MONITORING YEAR 3 ANNUAL REPORT

LONE HICKORY MITIGATION SITE

RE: Lone Hickory Mitigation Site – Monitoring Year 3 Report Draft
Yadkin River Basin – CU# 03040101 – Yadkin County
DMS Project ID No. 97135
Contract # 6897

Wildlands Engineering, Inc. (Wildlands) has reviewed the Division of Mitigation Services' (DMS) comments from the Draft Monitoring Year (MY) 3 report for the Lone Hickory Mitigation Site. DMS' comments are noted below in **bold**. Wildlands' responses to those comments are noted in *italics*.

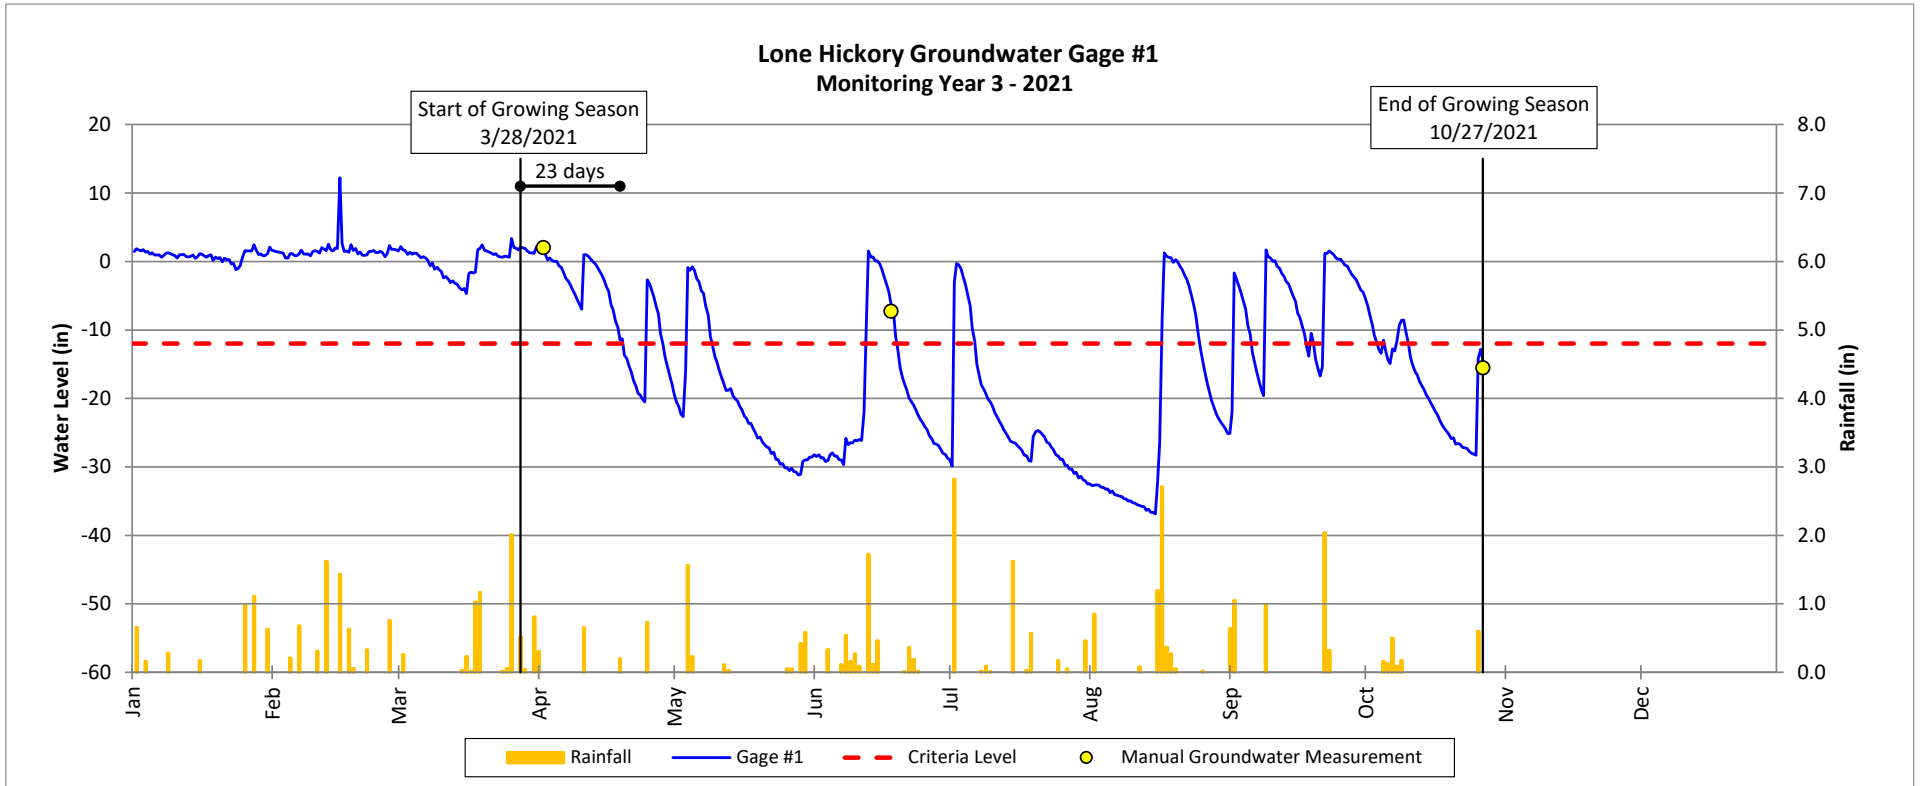
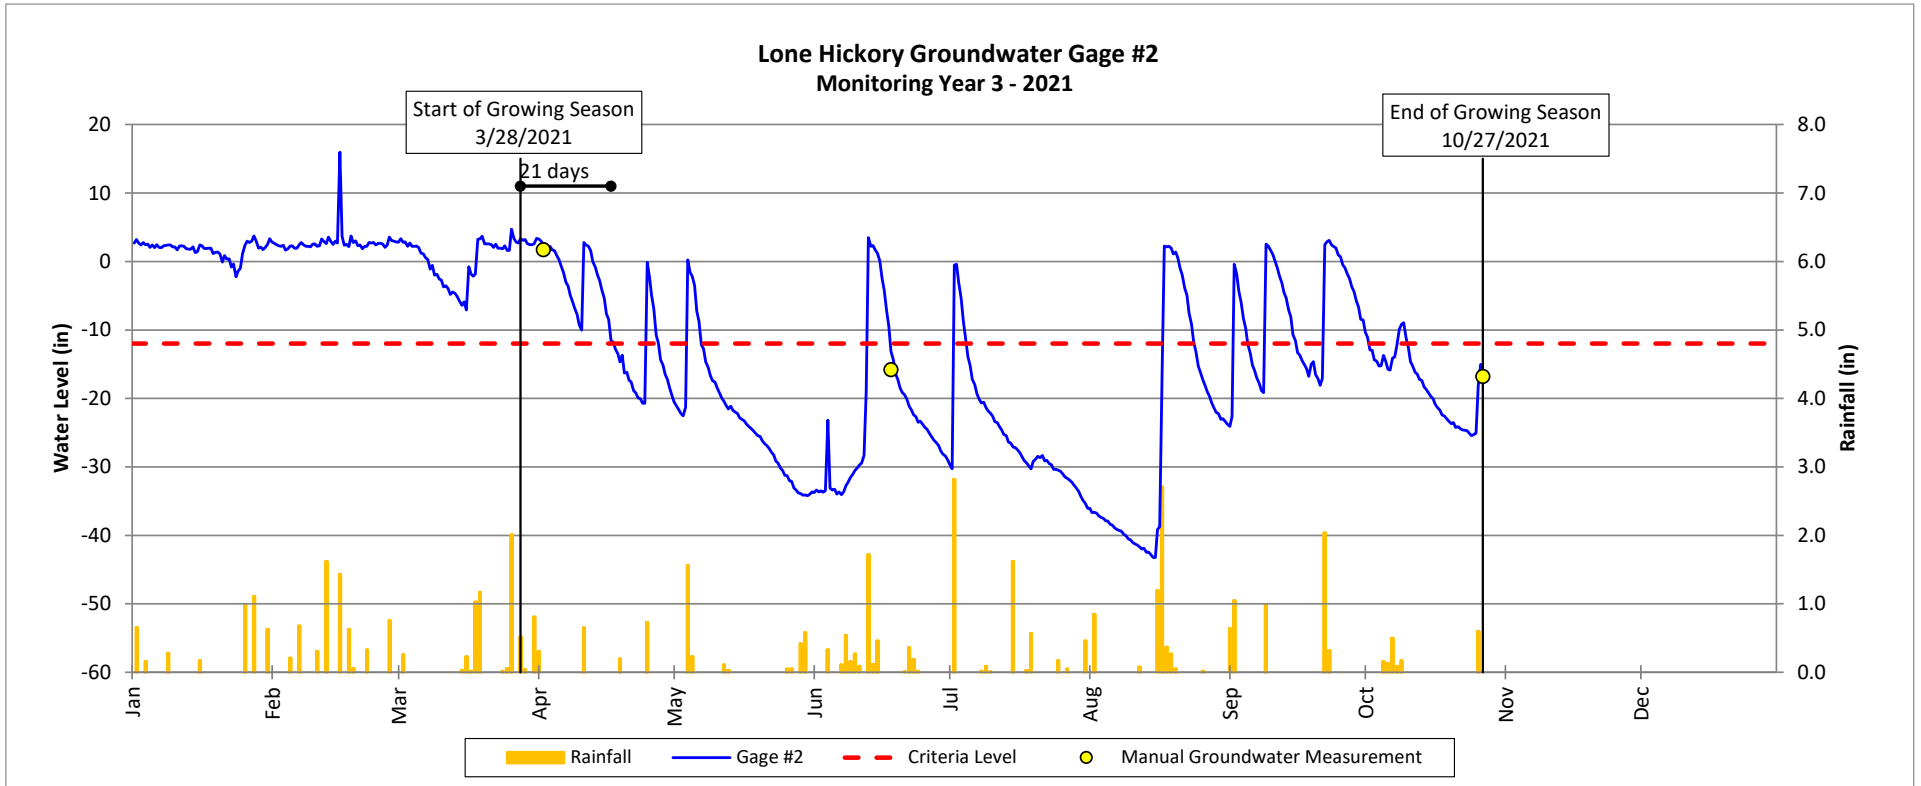
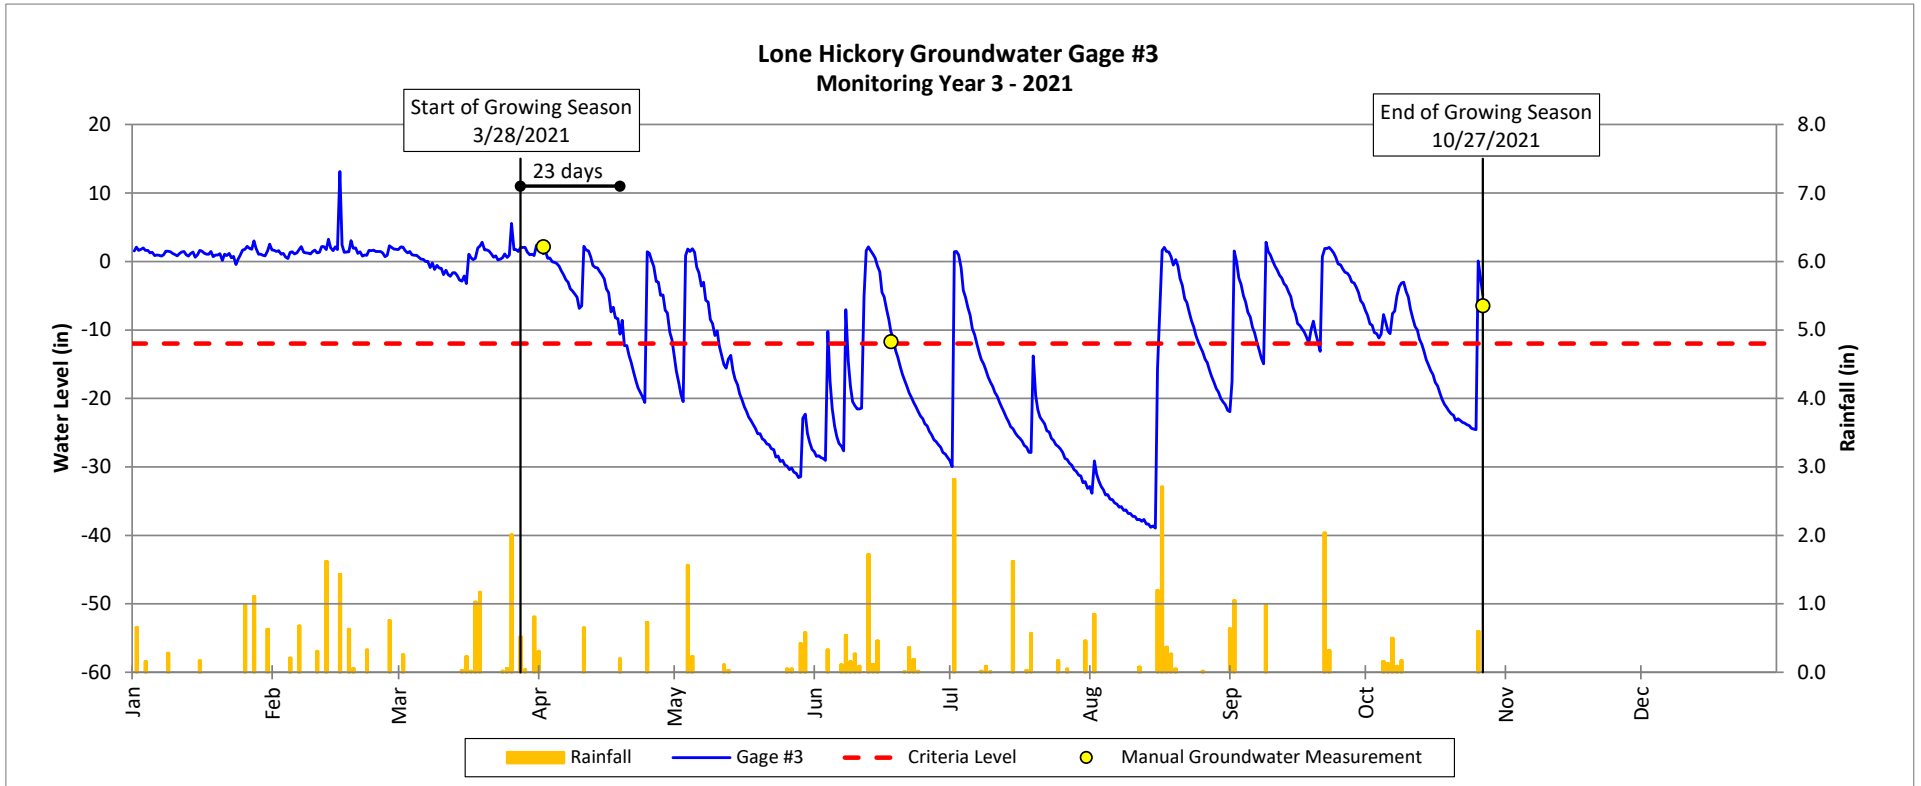
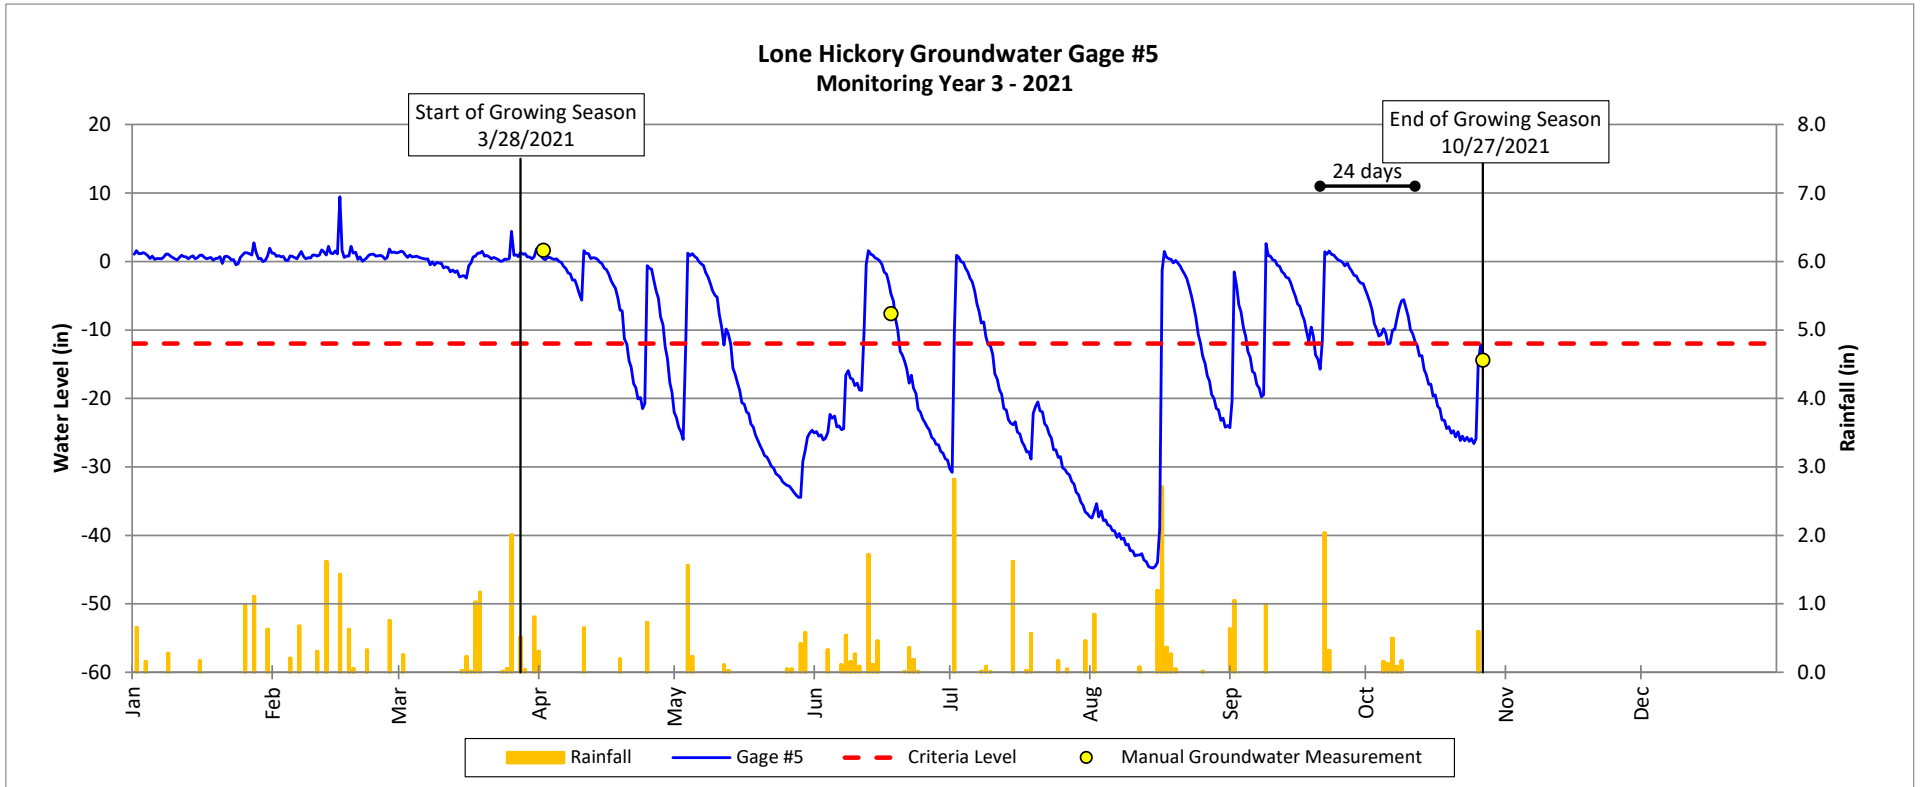
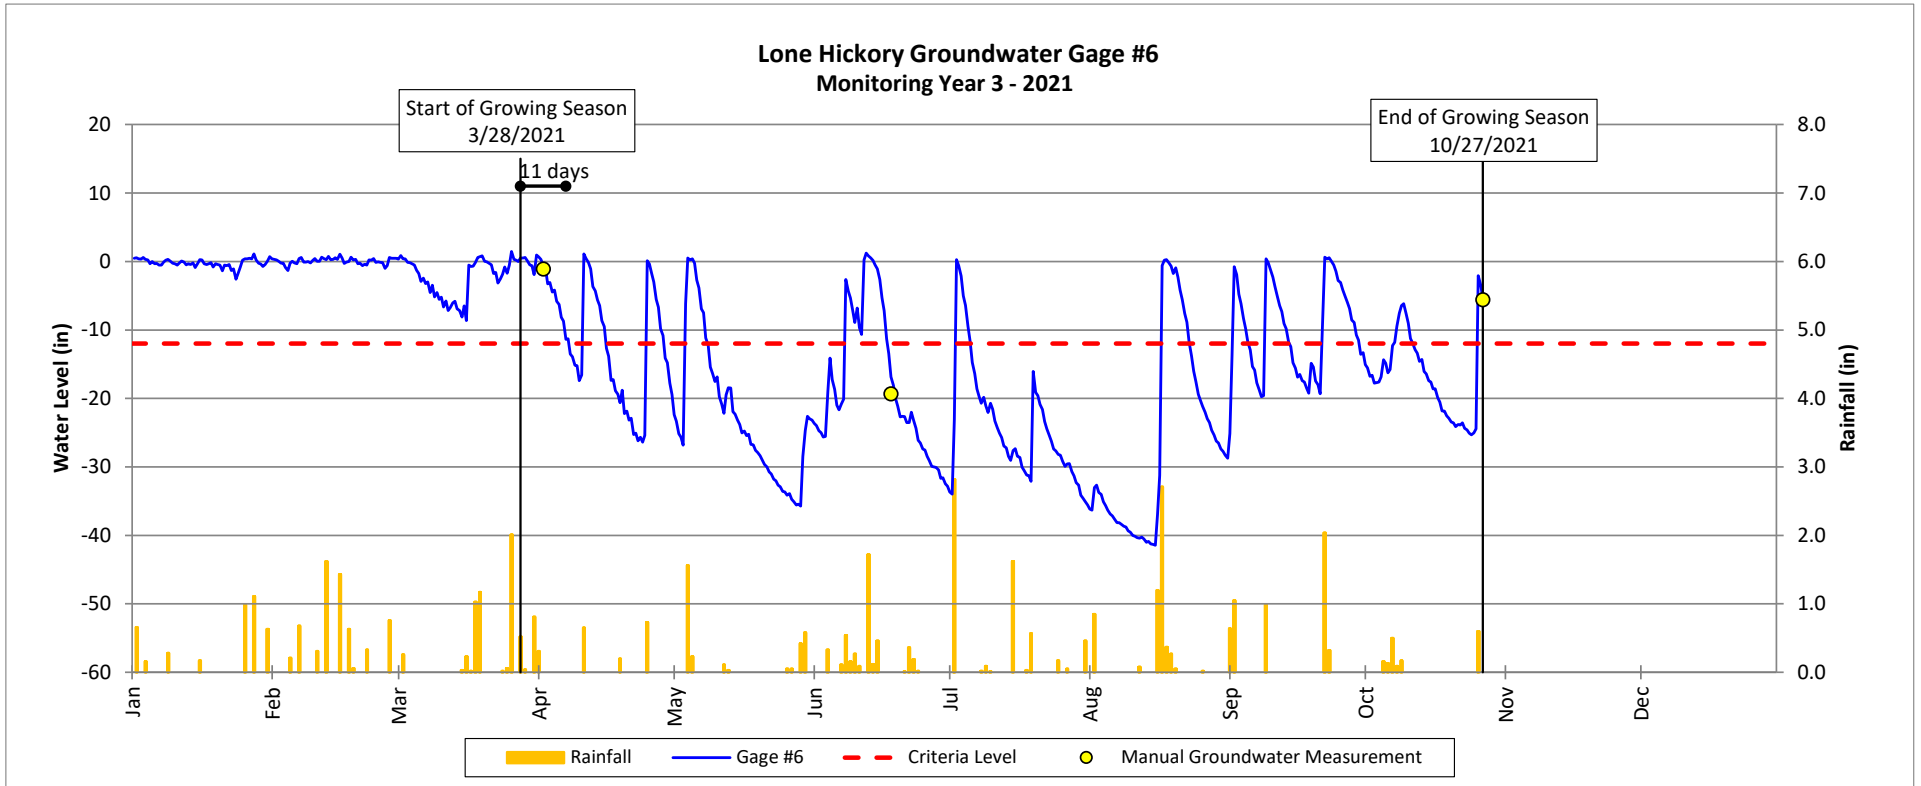
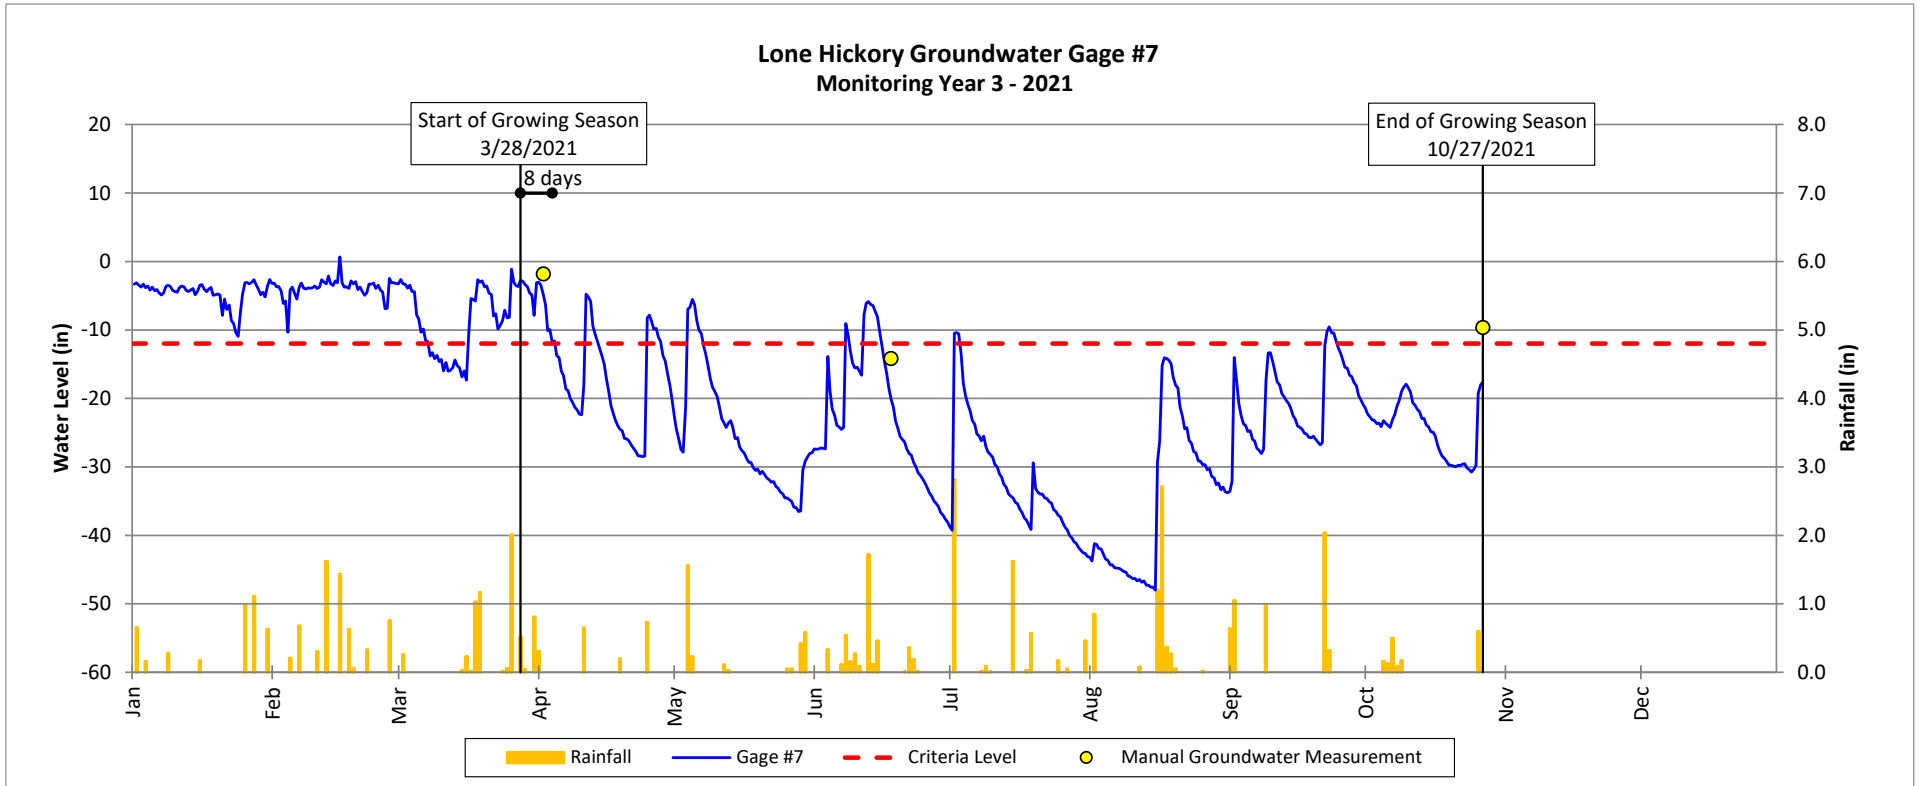
DMS' comment: General: Per the 12/8/2017 IRT approved mitigation plan; "The final performance standard for wetland hydrology will be a free groundwater surface within 12 inches of the ground surface for 19 consecutive days (9.2 percent) of the defined growing season for Yadkin County (April 4 through October 27) under typical precipitation conditions." The IRT approved mitigation plan does not mention the use of bud burst data or soil temperature data to amend the established growing season.

Additionally, the IRT has indicated that if mitigation providers intend to utilize bud burst and soil temperature data to extend the start of the growing season then they must also utilize this data to amend the end date of the growing season. In some cases, the IRT has allowed the use of the most current WETS (USDA 2021) data to determine the growing season start and end dates; however, the IRT has indicated that they do not want growing seasons to vary in each monitoring year.

If Wildlands intends to amend the growing season dates established in the IRT approved mitigation plan, documentation and approval will be required from the IRT. The IRT will likely require a mitigation plan addendum to amend the established growing season dates.

While it is acceptable to provide complimentary/ comparison data in the report appendices, the text, tables, groundwater gage plots and CCPV maps should clearly report monitoring results based on the established success criteria. Please update the MY3 (2021) report and digital support files based on the success criteria established in the 2017 IRT approved mitigation plan.

Wildlands' response: At the present time, Wildlands does not intend to amend the established growing season dates from the approved Mitigation Plan. Text in the executive summary, Section 1.2.4, and Section 1.3 have been updated and the monitoring results are based on the growing season dates established in the approved Mitigation Plan. CCPV maps and Appendix 5 have been updated, as well. An analysis of the groundwater gage data with an extended growing season, beginning one week earlier on

March 28, 2021, is included in Section 1.2.4 for comparison purposes only. Supplemental groundwater gage and soil temperature plots have been added to Appendix 6.
